FINAL PRE-INJECTION STUDY WORK PLAN BIOREMEDIATION PILOT STUDY OPERABLE  
UNIT 3 BUILDING 780 NAS JACKSONVILLE FL  
08/03/2015  
SOLUTIONS-IES

**Responses to FDEP Comments on the  
Draft Revision 2 Pre-injection Study Work Plan  
Bioremediation Pilot Study  
Operable Unit 3 Building 780  
NAS Jacksonville, Jacksonville, Florida  
Report dated November 24, 2014, Comments dated July 14, 2015**

Re: Draft Revision 2 Pre-Injection Study Work Plan, Bioremediation Pilot Study,  
Operable Unit 3 Building 780, Naval Air Station Jacksonville, Jacksonville, Florida

SITE MAP  
 BUILDNG 780  
 NAVAL AIR STATION JACKSONVILLE  
 JACKSONVILLE, FLORIDA

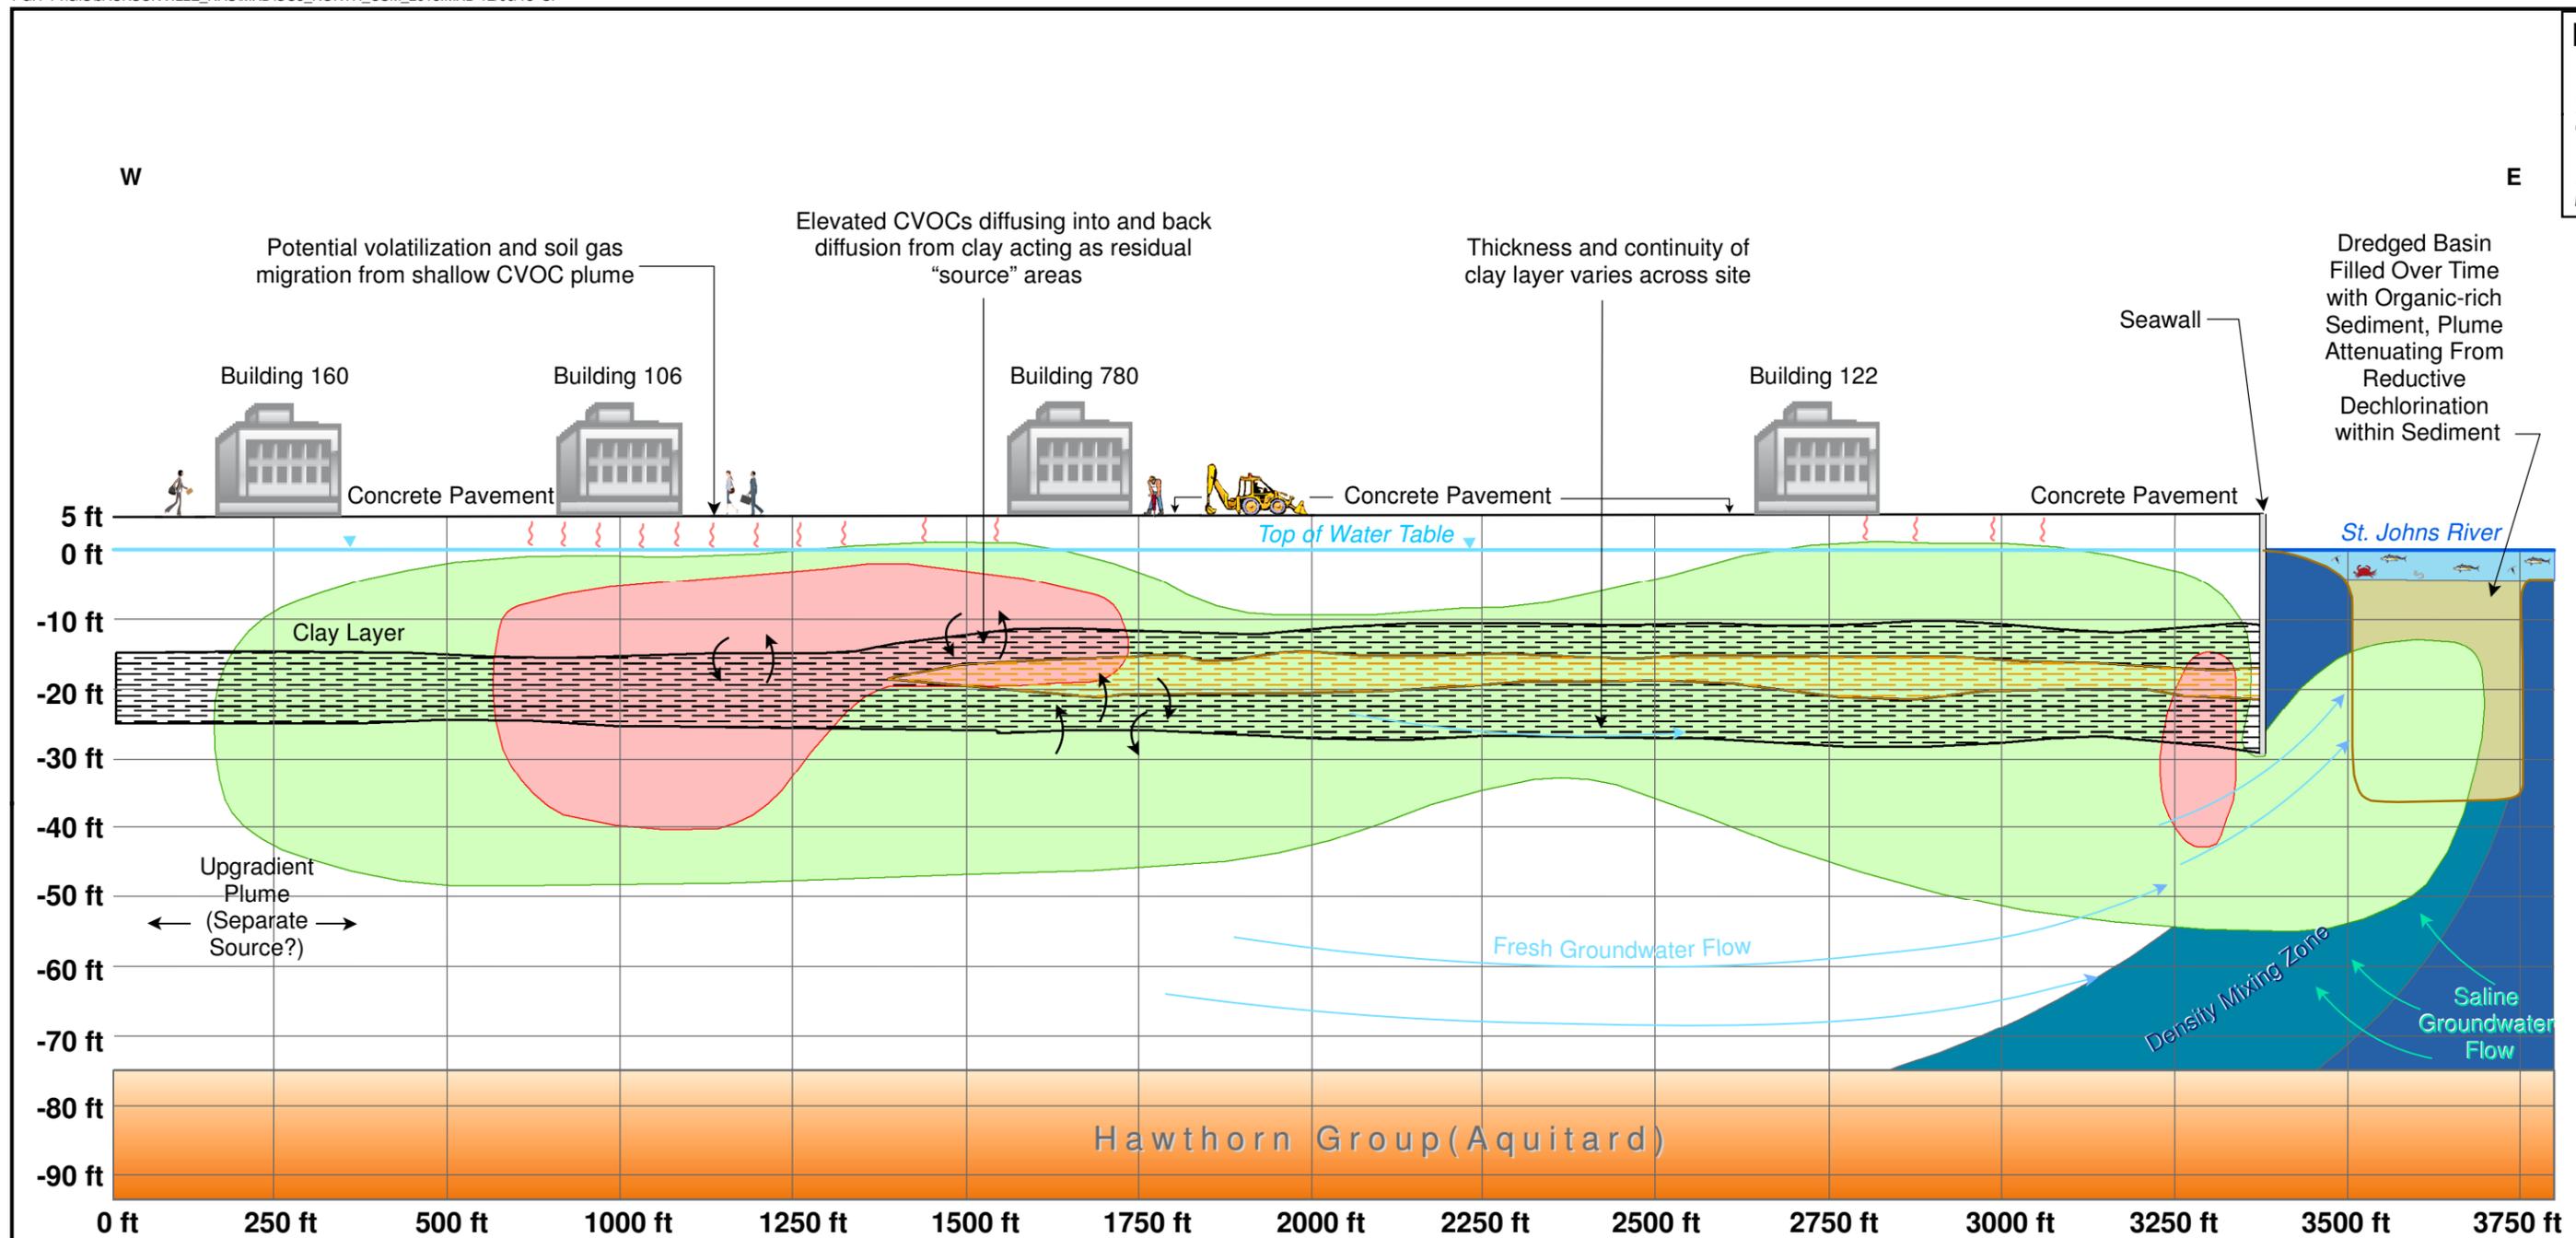
- (2) Have the sewer lines shown on Figure 2, which run near Building 780, been examined with a camera to confirm their integrity? Confirmation of sewer line integrity may be of value in preventing possible short-circuiting of the injected amendment during the future pilot study EVO injection activities.

**Response: The sewer lines have not been examined with a camera for their integrity. The targeting interval for injection is directly above the clay layer at the site (estimated 15 ft bgs). The intention is to not inject near the depth of the sewer lines. However, during injection, the Navy contractor will observe the sewers to identify if amendment is entering them.**
